P 526696 UPGRADE

ON-SITE SEWAGE DISPOSAL SYSTEM HOWARD COUNTY HEALTH DEPARTMENT BUREAU OF ENVIRONMENTAL HEALTH

SUBDIVISION: Fulton Manor II LOT NUMBER: X / 1

MEMORANDUM

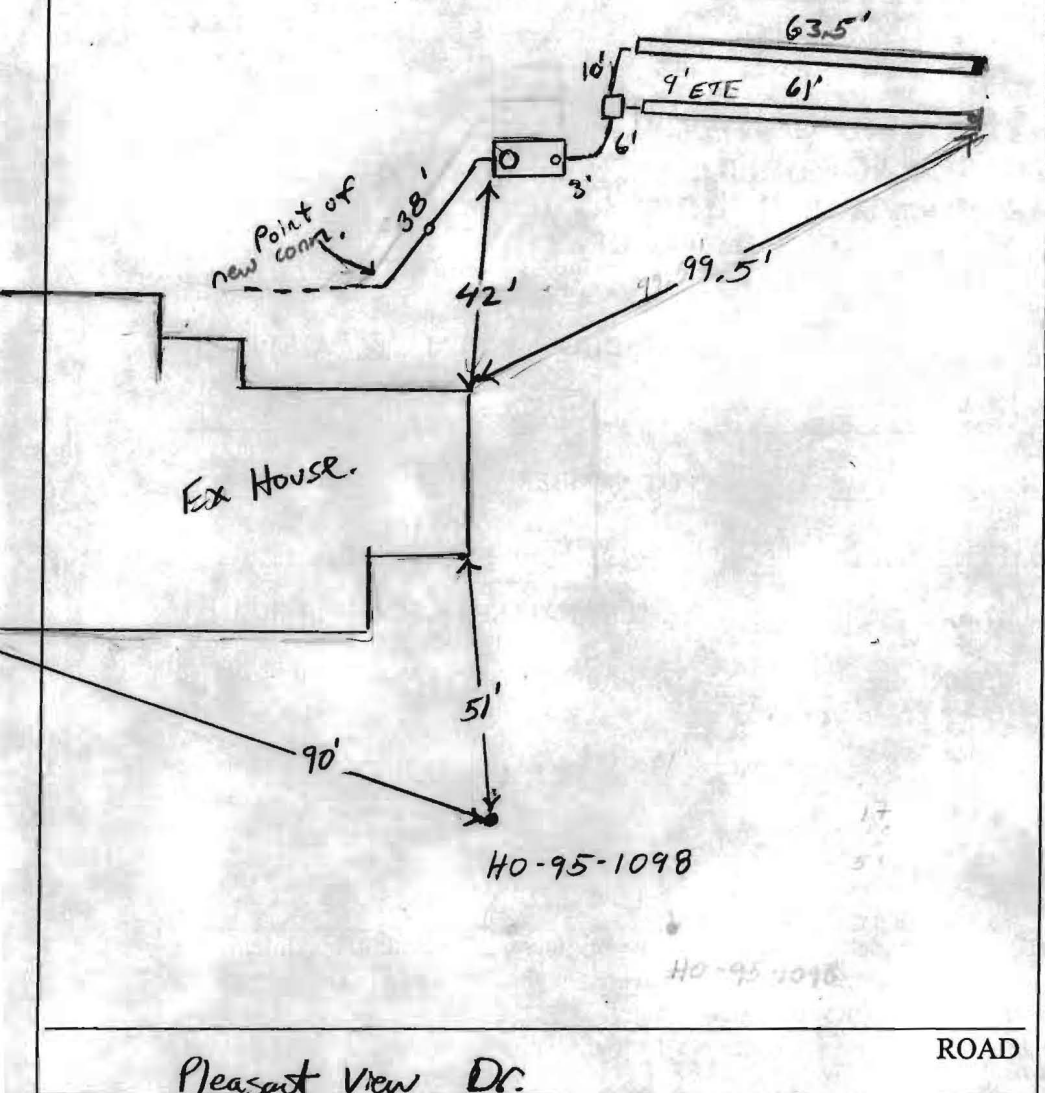
PRE-CONSTRUCTION 5/22/07 Keep tank 100' from 'new' well. Set D box
 Tip Center of SDA. Install 2x 62' trenches towards right lot line.
 INSTALLATION Trenches to be at this knoll. Remove topsoil off rear
 end of SDA. (KW) 5/22/07 Tank set per installation. Inform
 contractor he needs 6" Baffle on inlet of S.T. plus obs. pipes @
 ends of trenches. OK to continue (KW) 5/23/07 Trenches
 installed per plan. 6" Baffle in S.T. trench in D box.
 OK to backfill (KW)
